NEW MEXICO  
ENVIRONMENT DEPARTMENT

*Hazardous Waste Bureau*

December 11, 2008

**RE: APPROVAL WITH DIRECTION  
RAILROAD RACK LAGOON FAN-OUT AREA EXCAVATION WORK PLAN  
WESTERN REFINING SOUTHWEST, INC. GALLUP REFINERY  
EPA ID #: NMD000333211  
HWB-GRCC-07-002**

**FIGURE 6**  
**RAILROAD RACK LAGOON OVERFLOW DITCH, FAN-OUT AREA SOIL SAMPLE LOCATIONS, AND RESULTS AND CONFIRMATION SAMPLE LOCATIONS**  
**WESTERN REFINING, LLC**  
**GALLUP REFINERY**  
**GALLUP, NEW MEXICO**

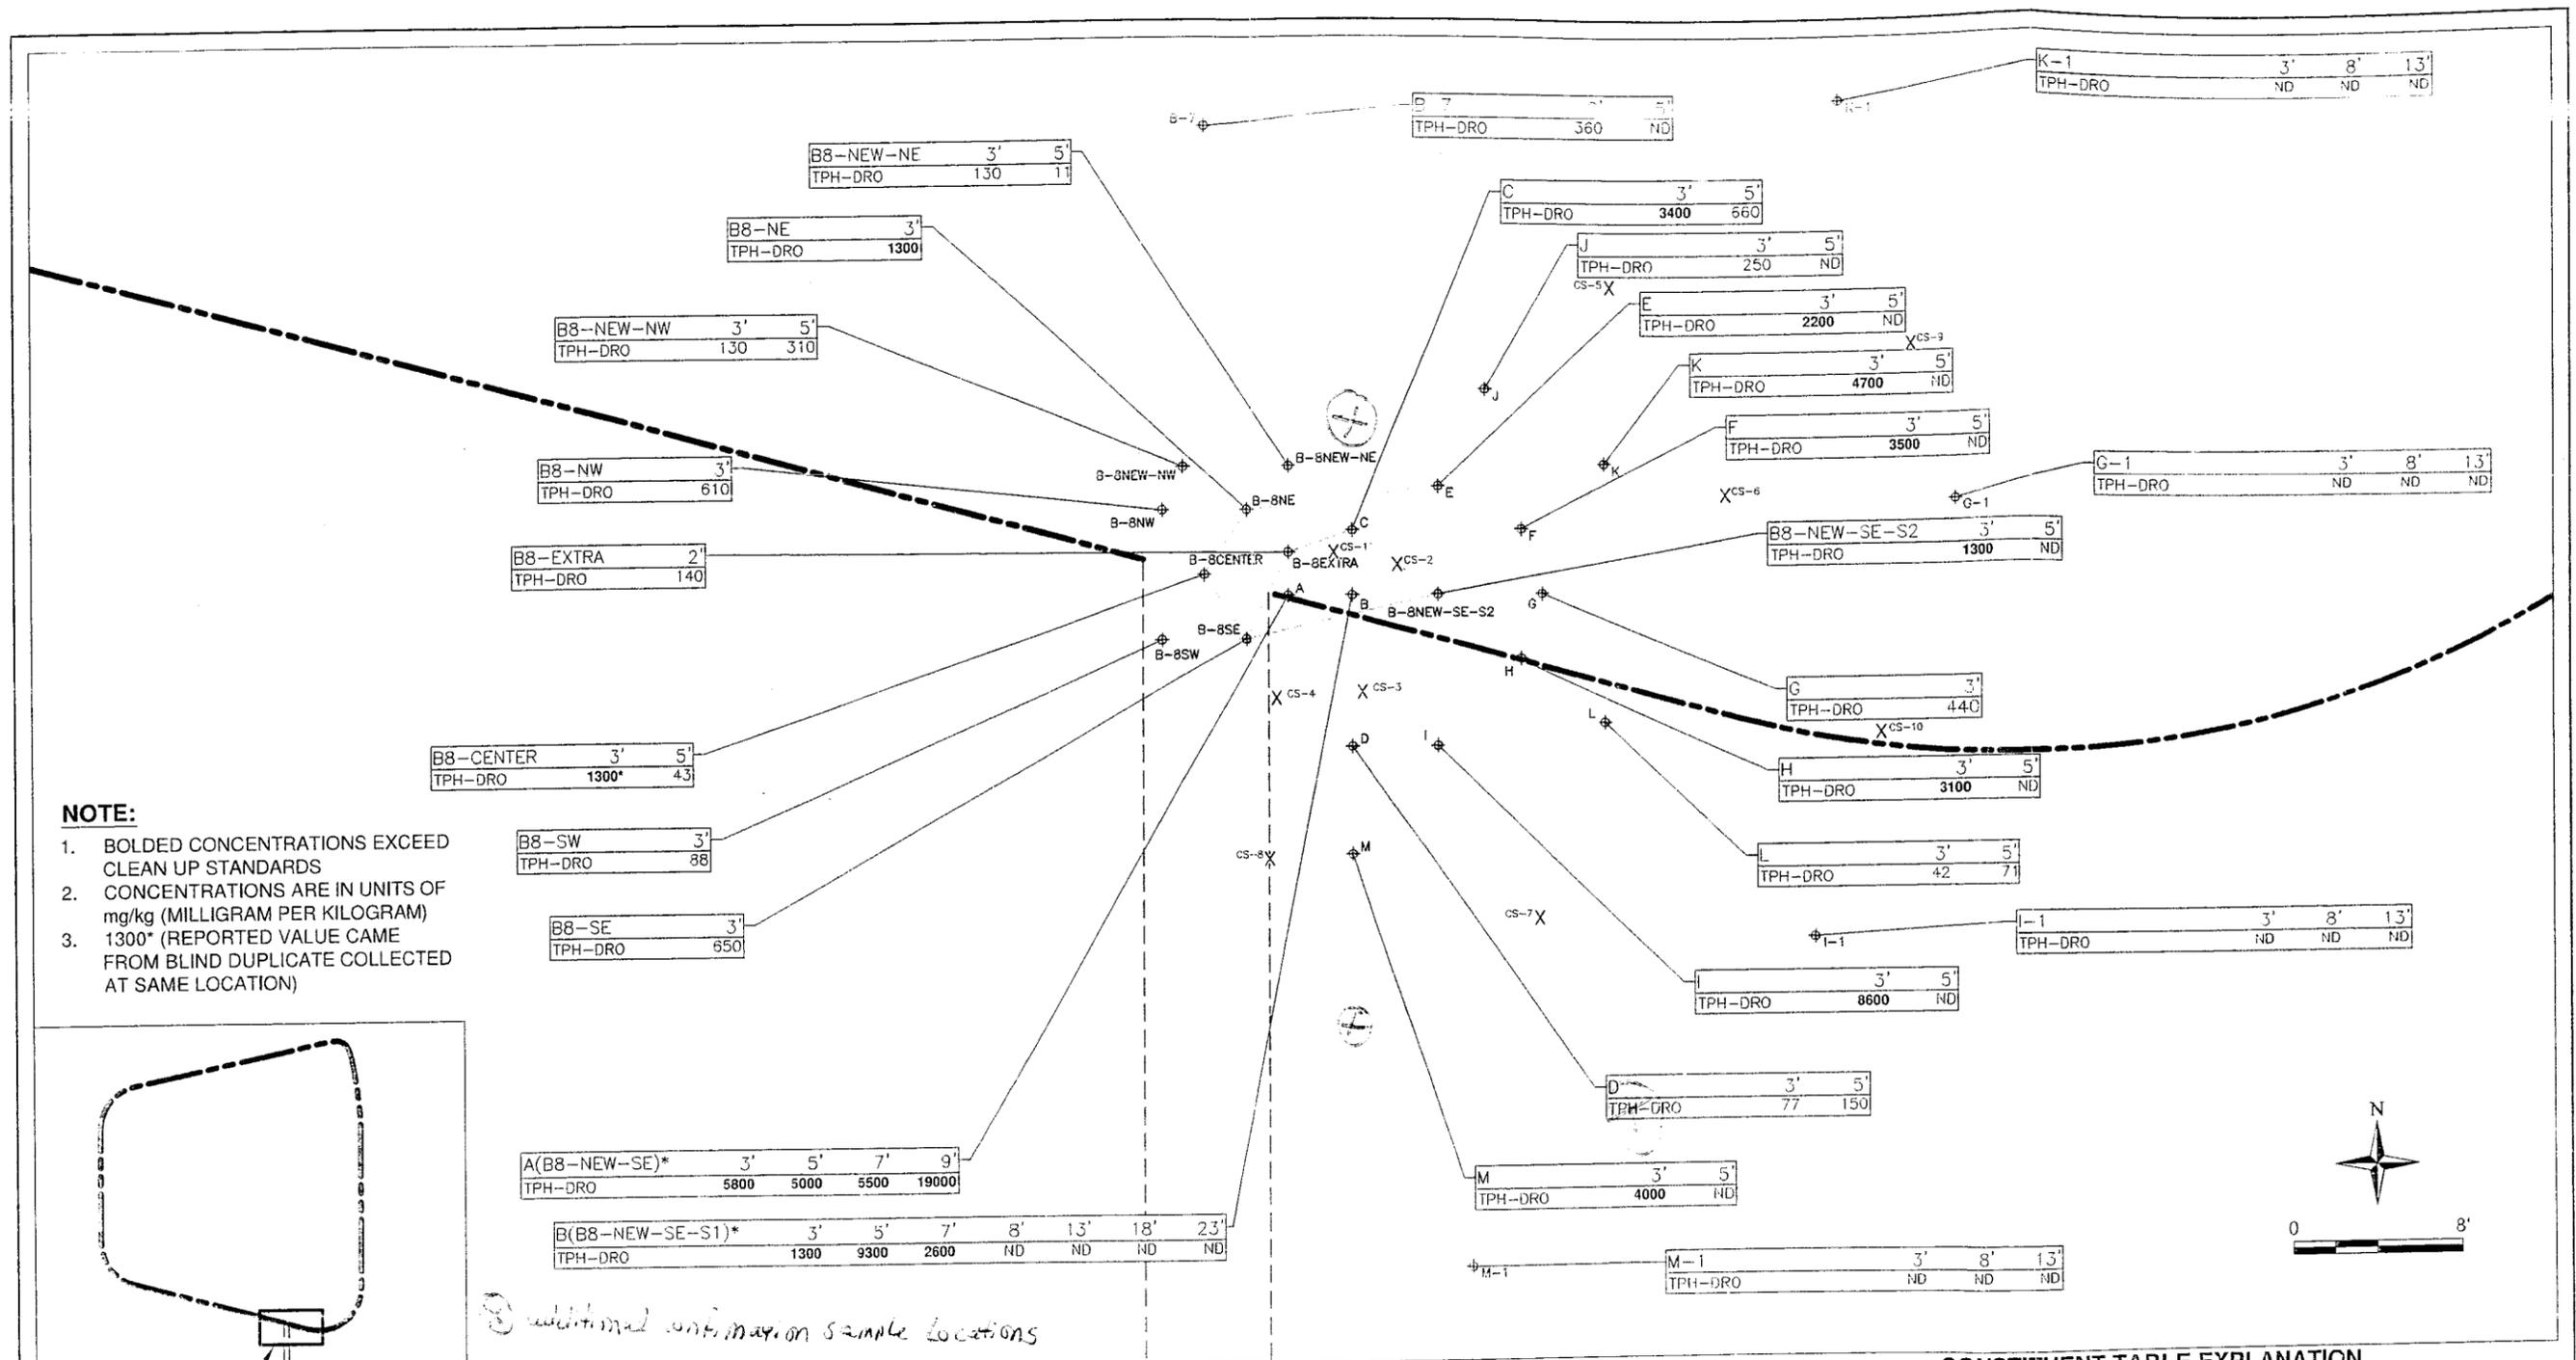
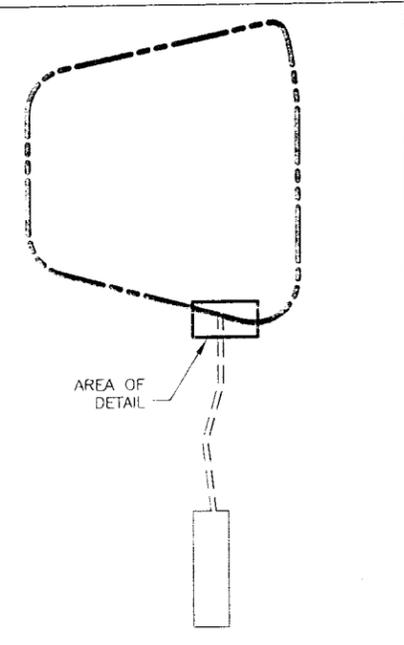
One borehole to a depth of 23 feet below ground surface is not representative of the entire area to be excavated (as shown in Figure 6) and cannot be used delineate the vertical extent of DRO contamination. Note, approximately four feet from borehole B8(B8-NEW-SE-S1) is borehole A(B8-NEW-SE) with a detected DRO concentration of 19,000 mg/kg at nine feet bgs. According to Figures 4 and 6, at borehole A(B8-NEW-SE), samples have not been collected below a depth of nine feet to determine the approximate maximum depth of contamination. Therefore, the Permittee has not fully delineated the vertical extent of DRO contamination. During the excavation, the Permittee must ensure the vertical and horizontal extent of contamination has been delineated. See Comments 2 and 3.

NMED does not agree with the proposed confirmation sampling. The Permittee is asking NMED to approve a specific number of confirmation samples when field conditions may prove

otherwise. Additional confirmation bottom and side-wall samples may be necessary to demonstrate compliance. NMED has the following comments related to the remedial activities:

- a. There are data gaps in the delineation of the vertical and horizontal extent of DRO contamination. For example, in reference to Figure 6, sample points K, H, I, and M were sampled at depths of three and five feet. These locations have DRO detections above the cleanup standard at three feet and detections below the cleanup standards at five feet. The Permittee has not demonstrated that between three and five feet, the DRO concentrations in the soil are below the cleanup standard of 890 mg/kg or whether additional soil must be removed between these depths. In addition, there is approximately 20 feet between locations J, K, G, H, I, and M and K-1, G-1, I-1, and M-1. With the exception of location L, there are no sampling locations or analytical data to demonstrate if DRO is present in soil at concentrations greater than the cleanup level within this 20 foot gap. (See items b-e)

- b. The area to be excavated to 13 feet may require additional bottom and side-wall confirmation samples than what was proposed in the Work Plan in order to demonstrate that residual soil DRO concentrations are below the clean up standard. This shall be determined by the Permittee based on field observations.

- c. Sample locations E, K, H, I, and M are all near the limits of the excavation between depths of three and five feet (as shown in Figure 6). Contamination is present at concentrations that exceed the cleanup standard at three feet at all of these locations. It is not clear if soils will be excavated to five feet or three feet at these locations. The Permittee must ensure that all of the contaminated soil is removed and that a representative number of confirmation samples are collected from the bottom and side-walls of the excavation to demonstrate successful removal.

- d. The Permittee must collect additional confirmation samples from the following locations: between CS-8 and M-1, between I-1 and M-1, and between 8-8NEW-NW and J. Confirmation samples must be collected from the bottom of the excavation. Side-wall confirmation samples must also be collected pending observations based on field screening. Side-wall samples must be collected to demonstrate that all soil containing DRO contamination at levels greater than the cleanup standard has been removed. NMED has provided an attached Figure (6) that identifies the additional locations for confirmation sample collection (locations are marked in red with a circled X). The Permittee may need to collect additional confirmation samples based on field observations.

- e. The Permittee must use field screening methods to determine if additional excavation and confirmation sampling are necessary. Depending on field observations, it may be necessary to collect additional side-wall samples in addition to bottom samples (e.g., if contamination is found where it was not expected, excavation side-wall and bottom confirmation samples must be collected to demonstrate that contaminated soils have been removed).

The Permittee provides the following notation under “Explanation” in Figures 4 and 6 that states “\* A(B8-NEW-SE) = MAY EVENT(AUGUST EVENT)” and “\* B(B8-NEW-SE-S1) = MAY EVENT(AUGUST EVENT).”

If these notations are depicted on the figures in the final report, the Permittee must explain their meaning.

*Additional confirmation sample locations*
